Specifications for Electrical Installations and Supplements

Errata and Revisions

January 2024

Electric System Bulletin 750 Series

Figure M-1 – Typical Primary Switchgear Metering Transformer Compartment Clearances

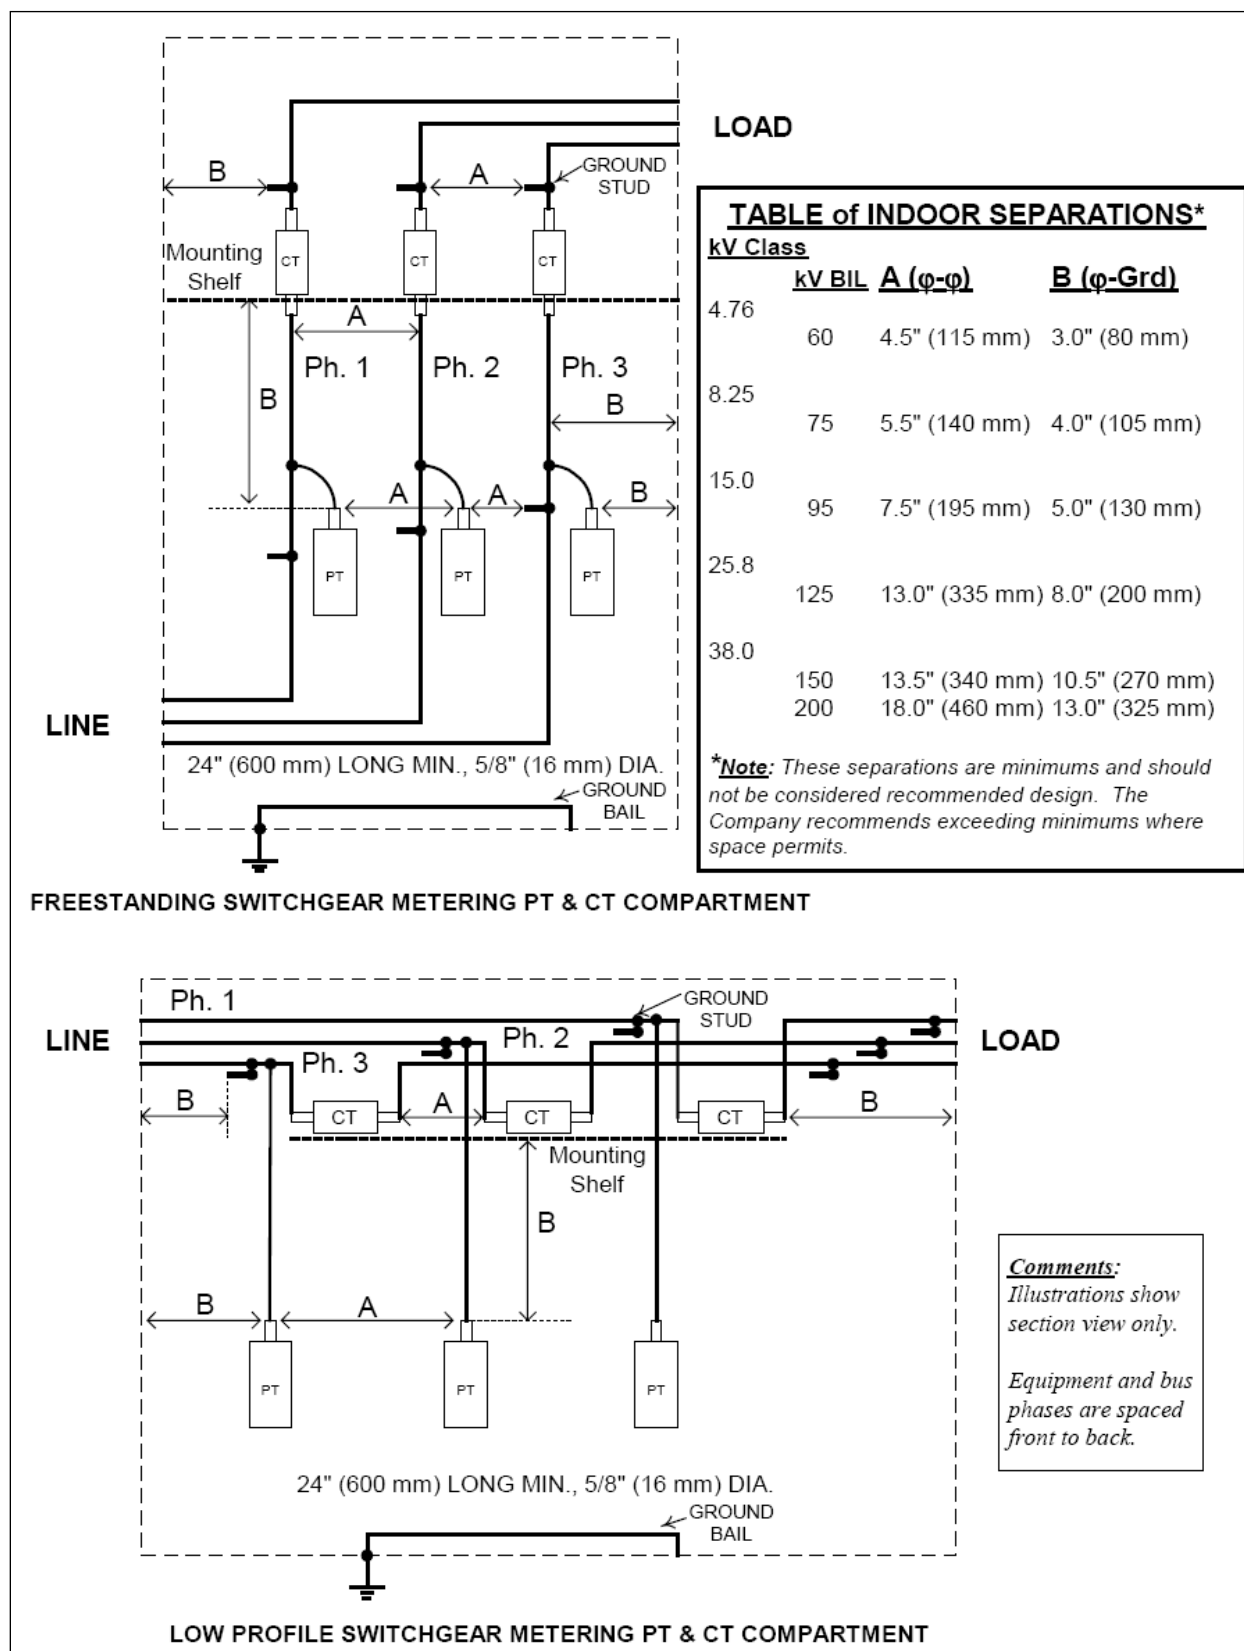
- d. The entire metering compartment shall be designed and constructed with adequate ventilation.
- e. The minimum width of the metering transformer compartment must be based on the electrical clearances of Figure M-1. The Customer shall maintain a minimum 10 ft. (3.0 m) unobstructed clearance in front of the metering transformer compartment access door.

- k. The metering transformer compartment shall be solely accessible by the Company. This requires section-to-section openings for through bus to be maintained as small as phase to ground clearances in Figure M-1 will allow.

- l. Where the clearances in Figure M-1 cannot be provided, Glastic (NEMA Type GPO 3 material) barriers are required between potential transformers and between potential transformers and the enclosure walls.

Figure M-1A – Typical Primary Switchgear Metering Transformer Compartments

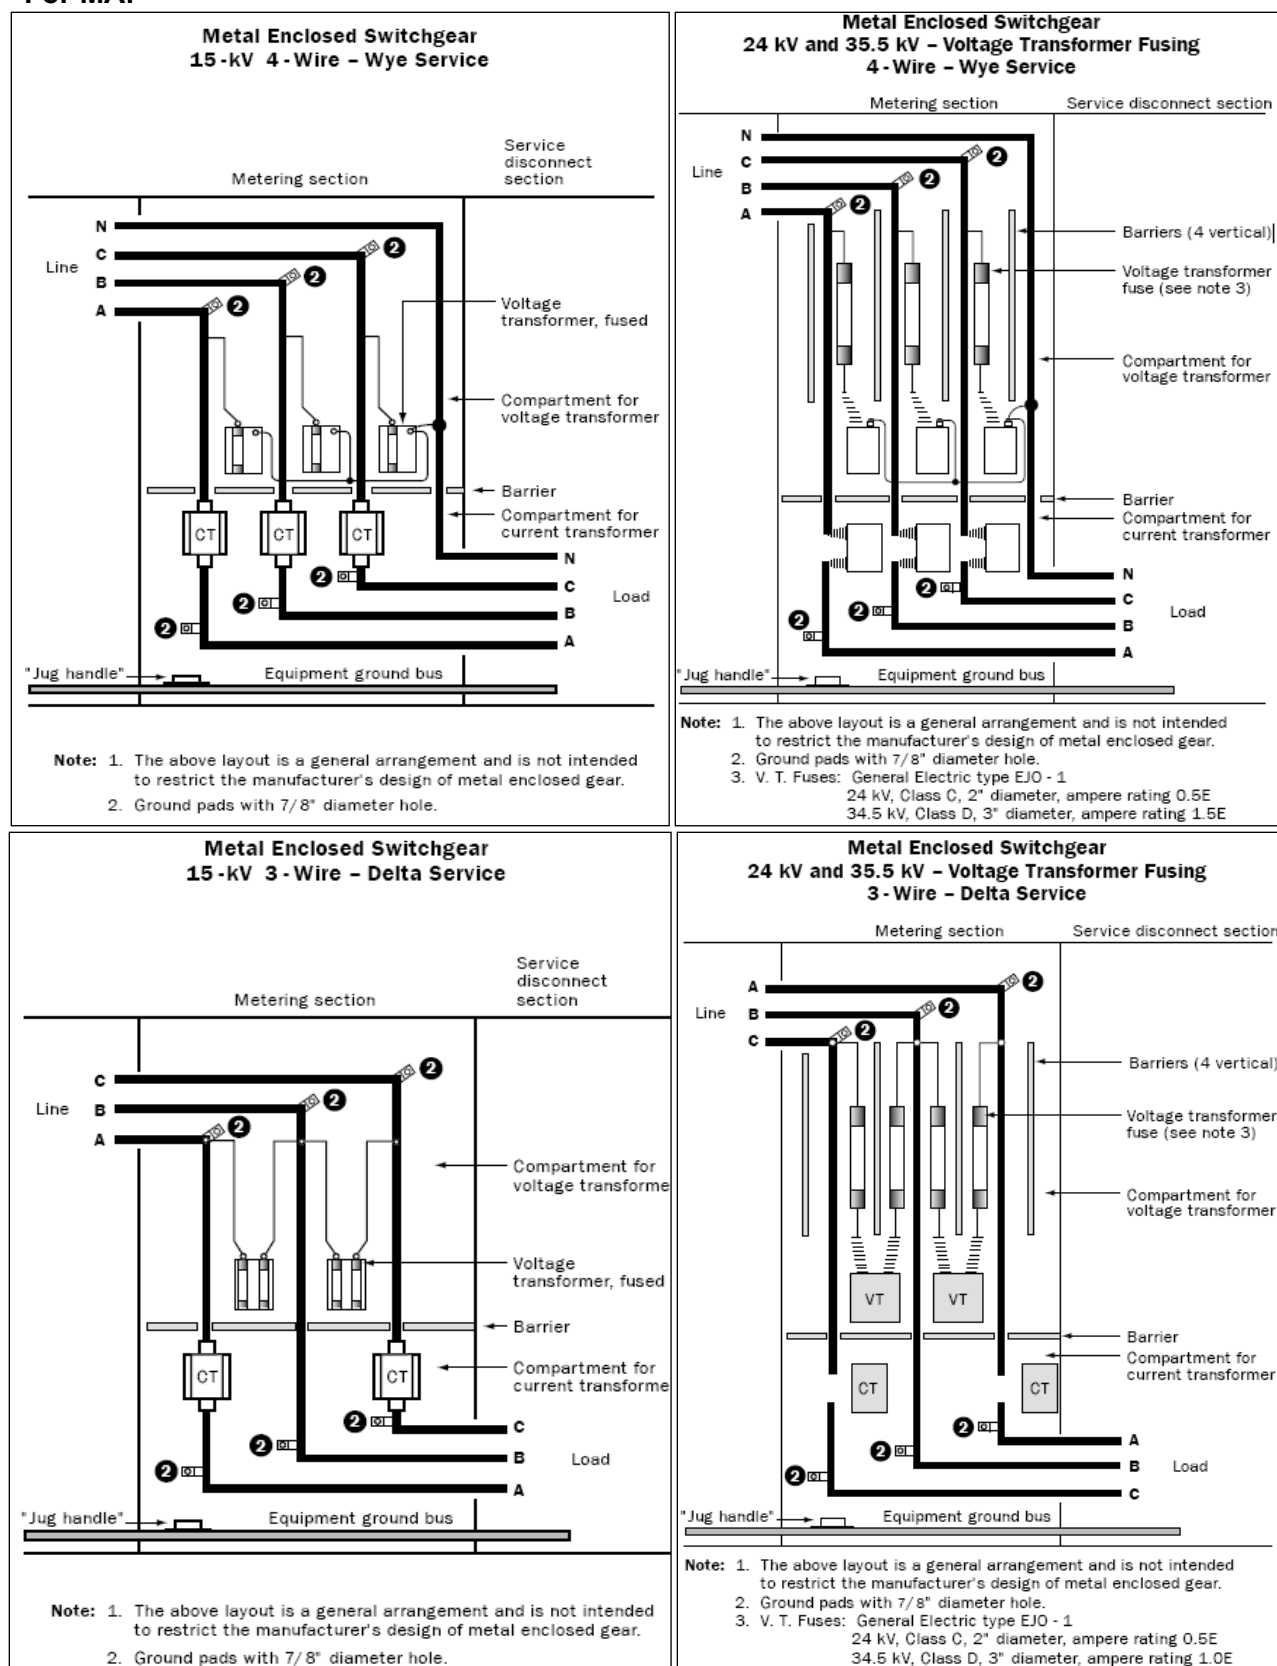
- p. A 5/8" (16 mm) dia. by 24" (600 mm) long copper ground bail shall be connected to the ground bus at both ends and located 7" (175 mm) behind the door and 5" (125 mm) above the door sill. In MA, ground pads and "jug handles" shall be installed on the equipment ground bus as shown in Figure M-1A.

Figure 1A – Clear Area Requirements in Front of Line Termination and Metering Transformer Compartments for 15kV Class Primary Switchgear

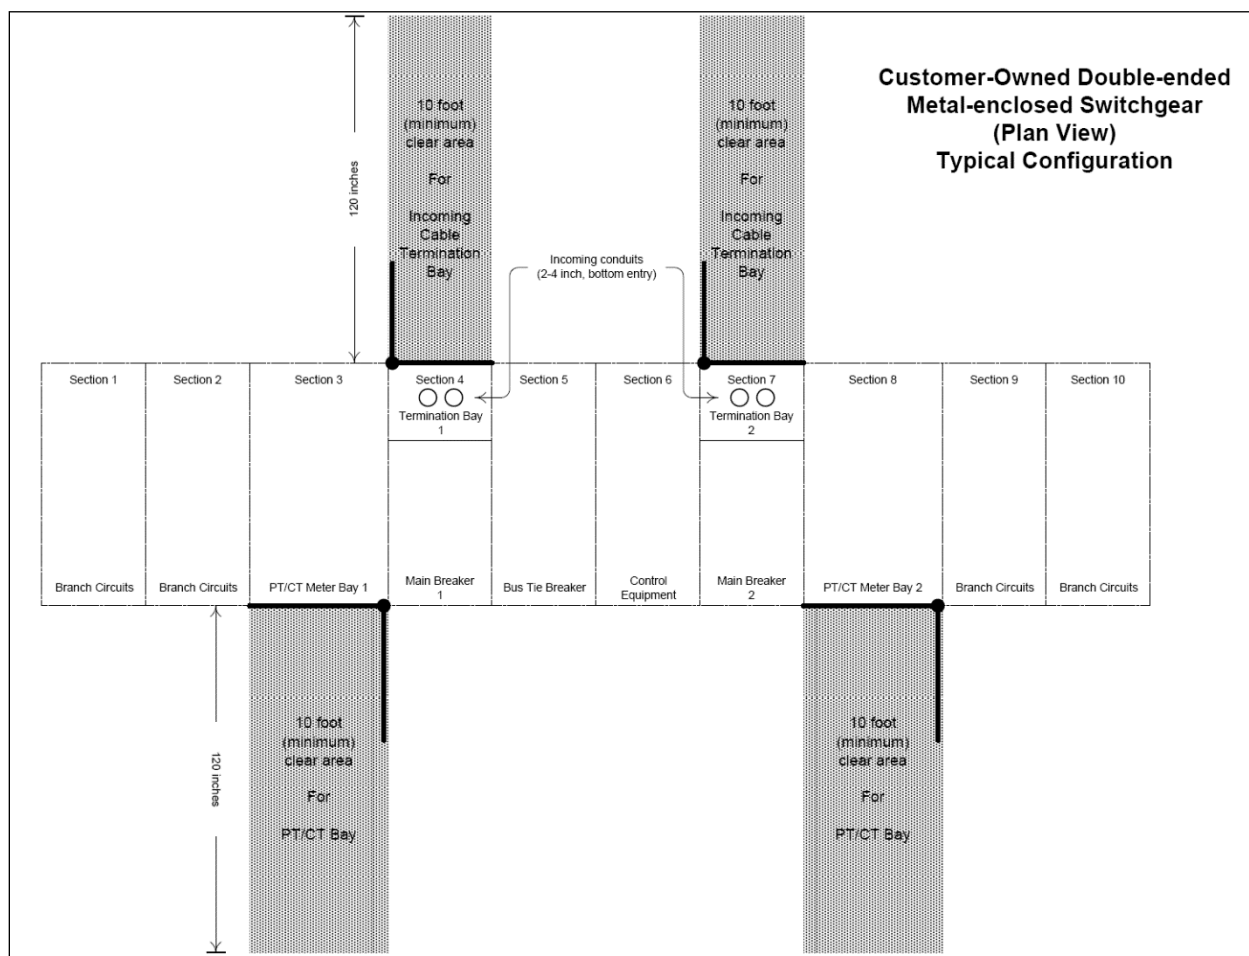
PAGE	SECTION	EFFECTIVE DATE	CHANGE
2	C Paragraph 11	Nov-1999	Delete the Inspection part in its entirety.
3	H	Nov-1999	Delete Paragraphs 18 through 20 and Paragraph 22.
4 and 5	I	Nov-1999	Delete Paragraphs 23 through 26.
5	J Paragraph 28	Nov-1999	In the first sentence, change “outdoor” to “indoor”.
8 - 10	M	Sep-2010	Change this metering section in its entirety and replace it with the new information ** below.
Fig. 1	Note #3	Apr-2002	In Note 3, change “see Paragraph 18” to “see ESB 750 Section 4”.
Fig. 1	Note #4 (new)	Sep-2010	Add new note: “Note #4: The clearances shown from the front of the service equipment to a building wall and from the rear of the service equipment to a building wall shall be both 10 foot (minimum) if the switchgear is designed with the Company required access to the incoming termination compartment on one side while the metering PT/CT compartment is on the other side; see Figure 1A. Otherwise, if the Company’s access to both compartments is on the same side, then the other side’s clearance can be reduced to the clearances presently shown.” Add new Figure 1A ** below.

Switchgear Collars

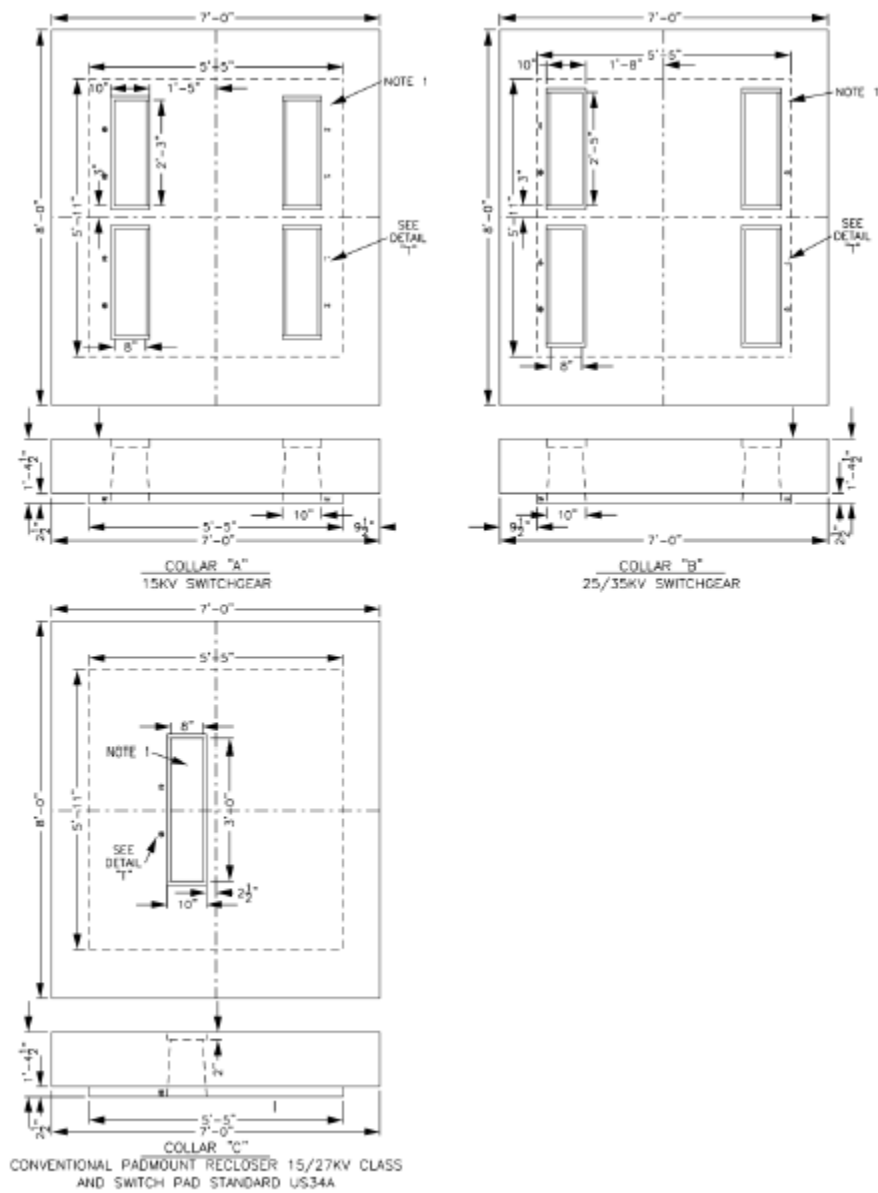
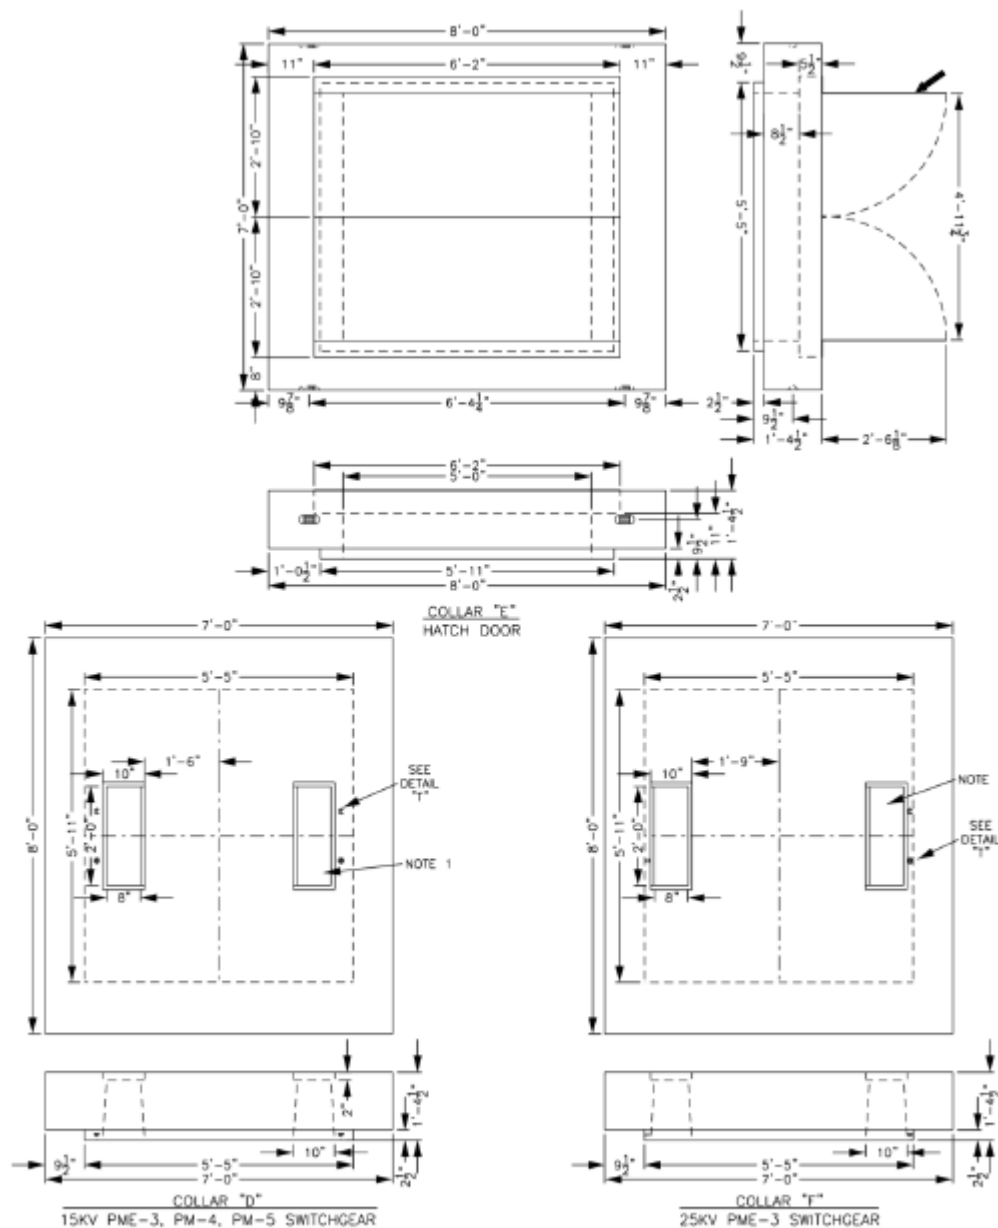
3.5	04/2022	Revised ESB 759B Figures 27.0-1, 27.0-2 & 27.0-4. Revised the Switchgear Collars in ESB 759B Section 25.2. Added new ESB 759B earth formed concrete language for Section 21.0. Added customer secondary cable testing requirement language to two different locations (Page 9 & Section 23.0). Replaced ESB 753 Figures with latest version. Updated ESB 750-2021 to 2022. Revised 756C & 756D in regard to UL1741-SB adoption.
